Re: Brentwood Hills Block 30 B, File H 22 D 4

ENCROACHMENT
SKETCH
BLOCK 30B
BRENTWOOD HILLS ADDITION

GRADING PLAN
REPLAT OF BLOCK 306
BRENTWOOD HILLS
SUNSHINE TOWNHOUSES

RE: SUNSHINE TOWNHOUSES DRAINAGE PLAN (REPLAT OF BRENTWOOD HILLS BLOCK 30B)

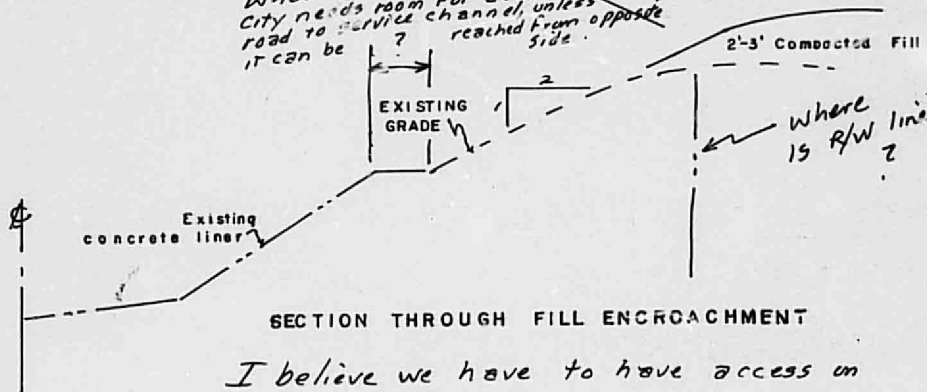
*Don't like what is pictured here ..
I think the owner should clear dirt
now or build retaining wall, to provide
truck access thru the affected area!*
Safe & comfortable
*(Comments in blue, on attached
sheets)*

What is this dimension?
City needs room for access
road to service channel, unless
it can be reached from opposite
side.

I believe we have to have access on
N. side of Piedra Lisa, to gain access
to E. side of Glenwood S. channel!

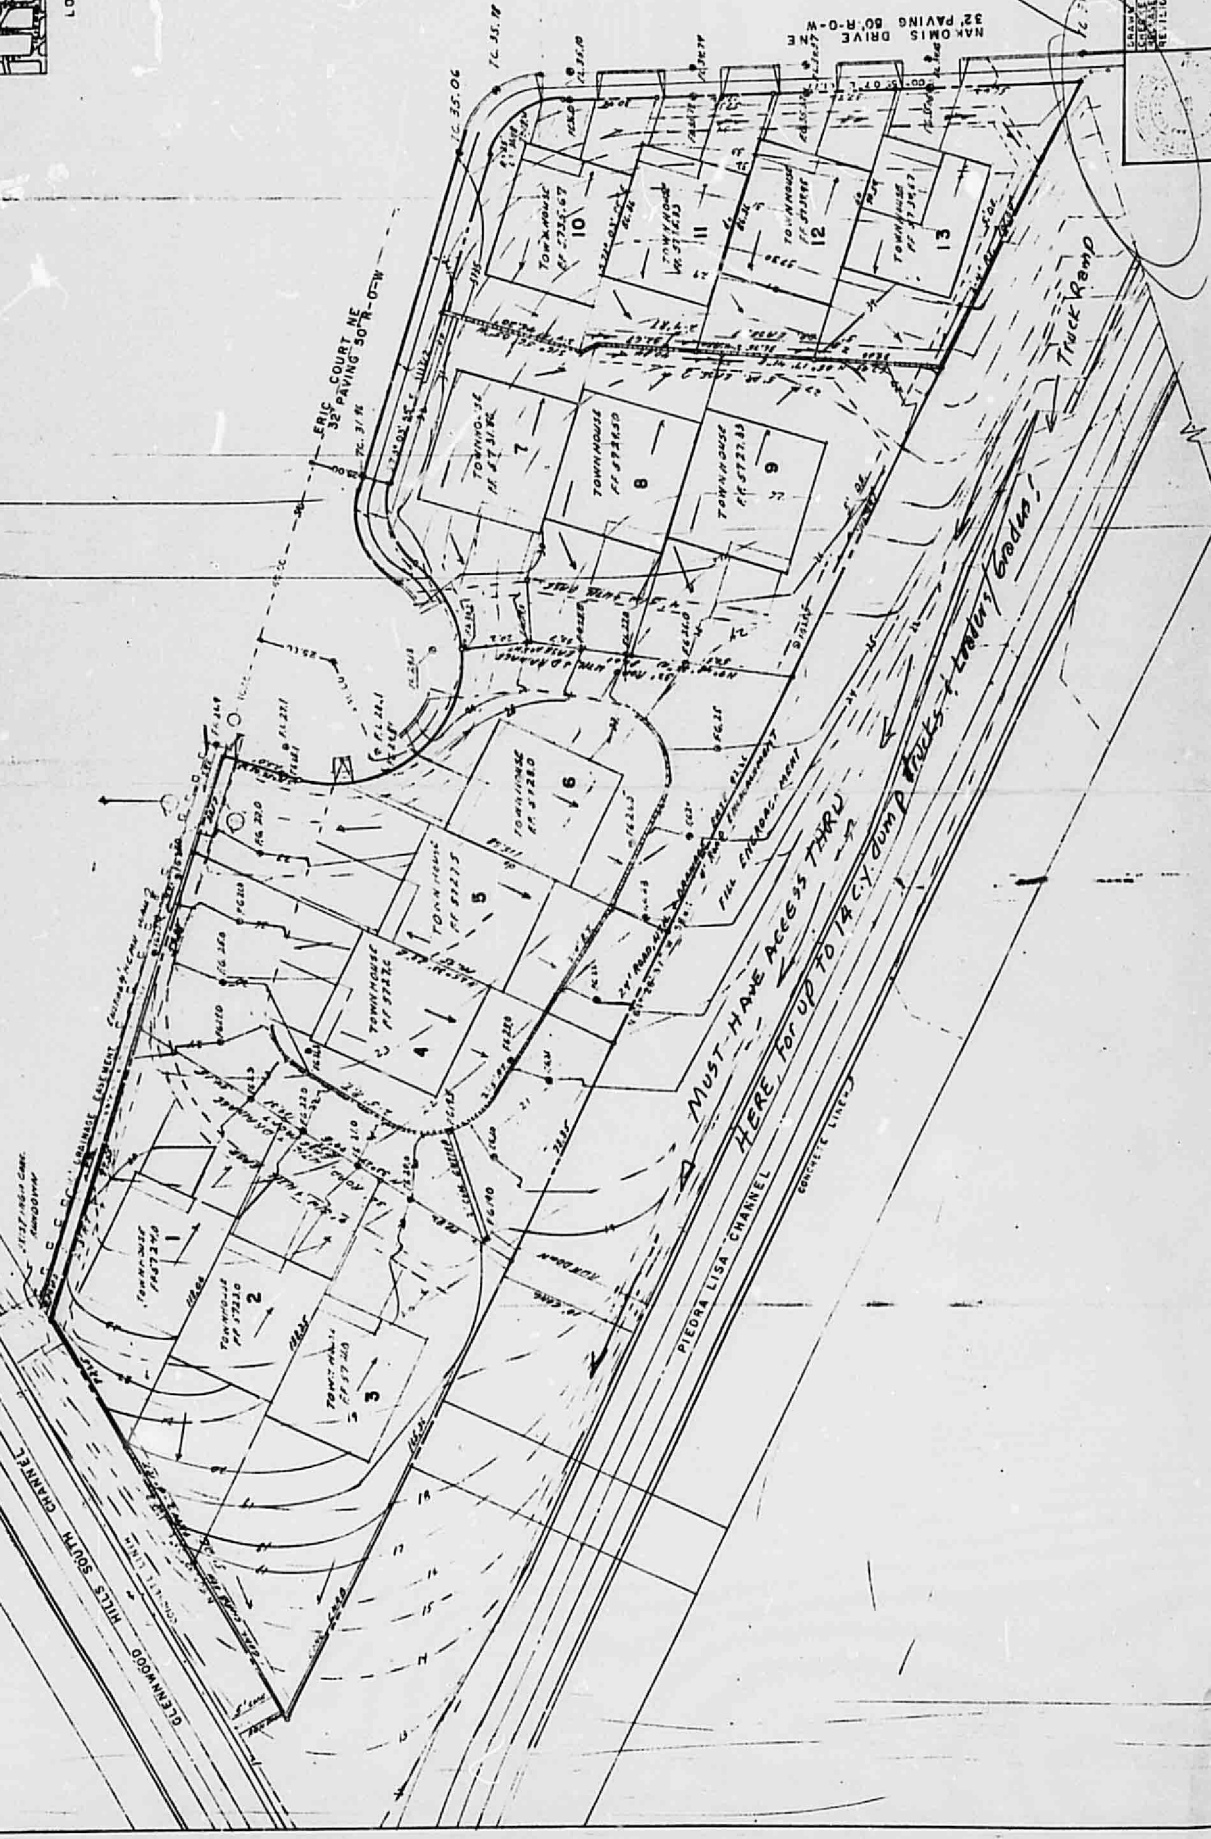
which side
is access to
gate to Lisa's
get to Lisa?
TERRACE SOUTH BOLT ON
FIRE RESTRAINT BOUNDARY
215-3-88

MUST HAVE ACCESS THROUGH
HERE FOR UP TO TRUCK RAMP

APPROVALS	NAME	DATE	TITLE: 10' RUNDOWN BLOCK 30 B BRENTWOOD HILLS 2801 NAKOMIS
A.C.E./DESIGN			PERMIT NO. SHEET 2 OF 4
INSPECTOR			
A.C.E./FIELD			
			MAP NO. H 22

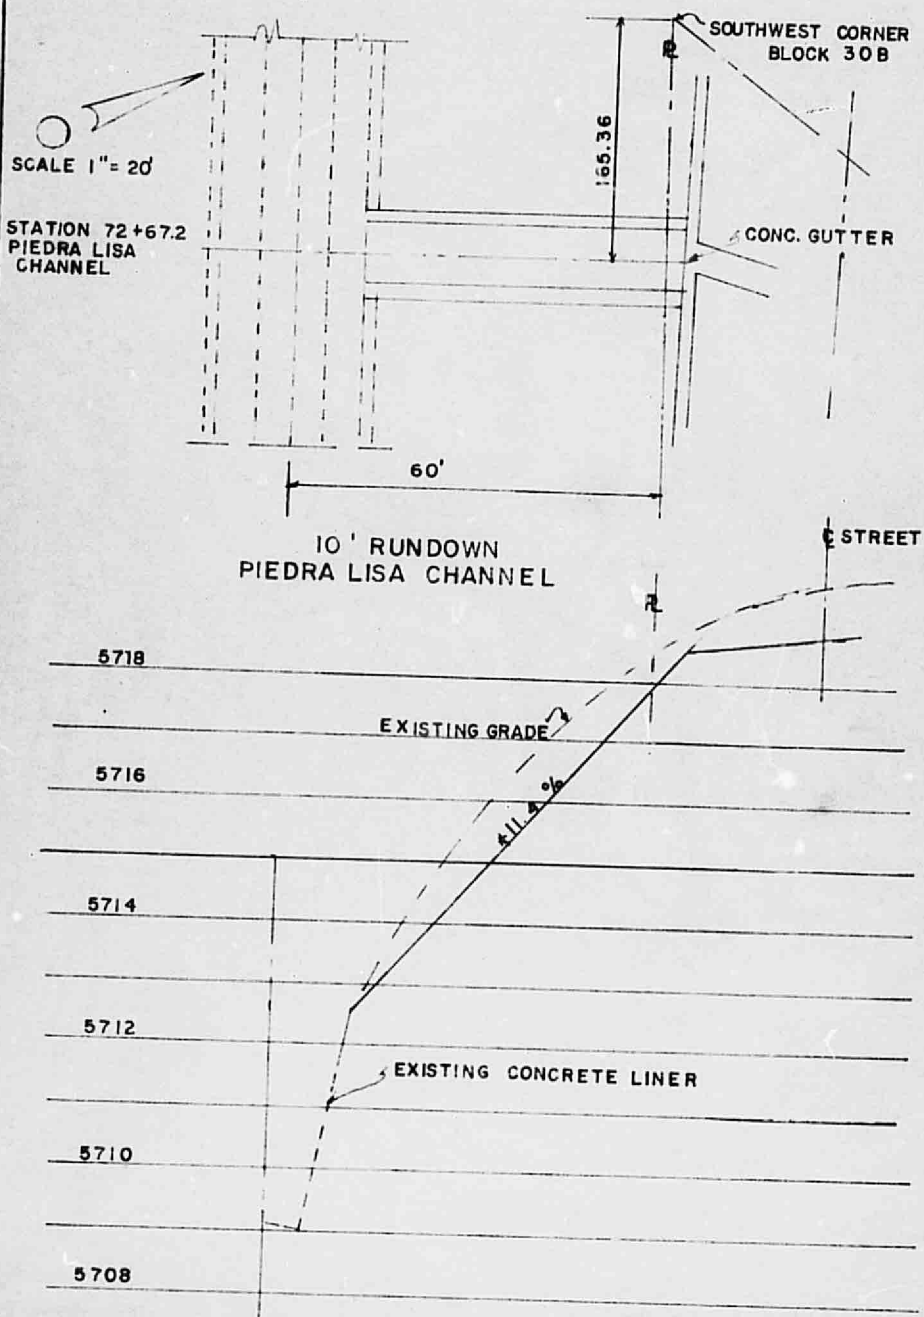
1. Relocate the Rundown on sheet 2
2. Add header curb at transition on rundown detail Sheet 2
- 2 3. Remove Channel detail sheets 2, 3, & 4
4. Change floor grades and street grades to assure the town house floors are above the street.
5. Correct North arrow sheet 4.

- ① Move 10 ft run down to center on inverted corner of street
- ② Correct North Arrow on sheet 4 (top-center)
- ③ Address slope in Piedra Lisa Channel. Will water stay in "Channel" when warped to meet Piedra Lisa?
- ④ How does water get to NW 5' run down in Glenwood Hills South Channel?
- ⑤ Grading Plan needs to show T/C's at critical points and show positive slope away from Buildings!
